Ref: 10530/3858

RE: PROPOSED MOSQUE – CROUDACE ROAD ELMORE VALE

This letter addresses queries raised by NCC in their letter to De Witt Consulting, dated 21/12/10 (ref. no. 10/1049), in reference to the noise assessment for the proposed mosque at 158A and 164 Croudace Road, Elmore Vale.

Figure 1 – Revised Acoustic Fence Location

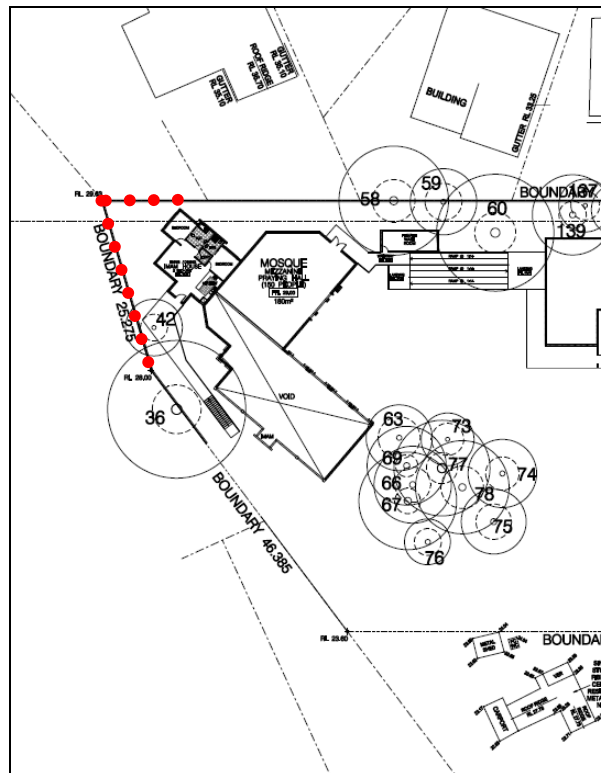
Paragraph 5 on P13 details a suggestion from the Urban Design Consultative Group that part of the acoustic fence at the northern end of the site be replaced with a more visually open timber screen. The location suggested adjoins the public reserve to the northeast of the site.

A review of the layout and the proposed activities on the site has shown that, due to acoustic screening effects of the structure of the mosque and, more significantly, the Imam house it would be possible to replace that part of the proposed fence as shown (dotted in red) below in **Figure 1**.

As indicated above the section of fence that may be replaced adjoins a public reserve. The replacement screen need not have any specific acoustic properties.

Figure 2 - Pre 7am Car Park Exclusion Zone

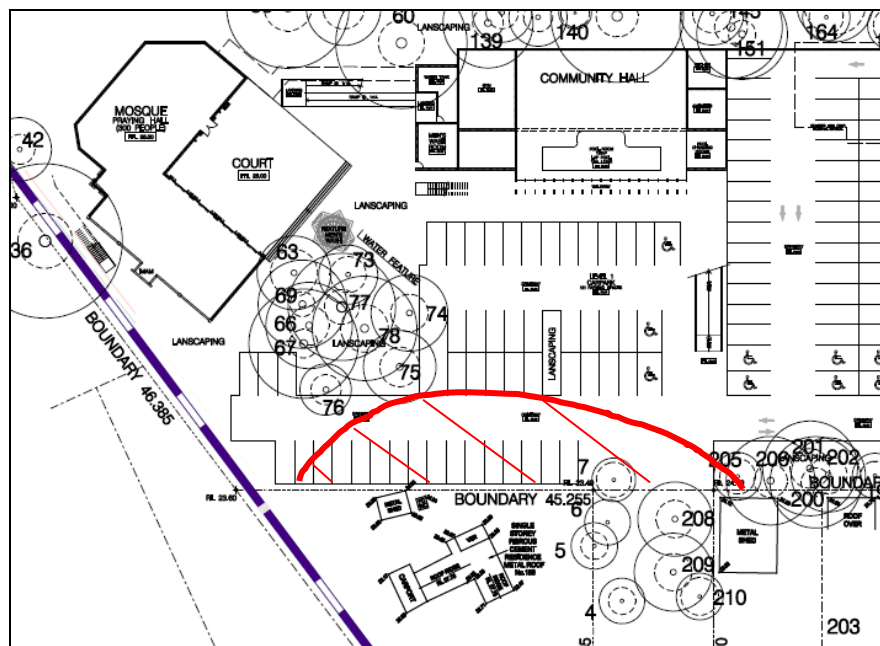
The NCC query relates to the potential for sleep disturbance from noise from cars bringing people to early morning prayers. Appendix II of the original acoustic report shows the “*Expected usage of the Facilities*”. For early morning prayers it is anticipated that there will be only 10 to 15 people present.

To minimise the potential for any adverse impacts signs will be erected at the top of the driveway and along the boundary fence with the residence at 158 Croudace Road, informing the congregation to respect the amenity of neighbours and not park in spaces near the fence prior to 7 am.

The exclusion zone area where parking is not permitted prior to 7 am is shown hatched in red on **Figure 2**, below. The received noise from the Lmax emissions from all other car parking spaces will not exceed the sleep disturbance criterion at any residences.

Definition of the exclusion zone can be dealt with as a condition of any development consent granted and managed on site accordingly through, amongst other things, appropriate signage and informing the congregation of the need to respect the amenity of neighbours and minimise noise.
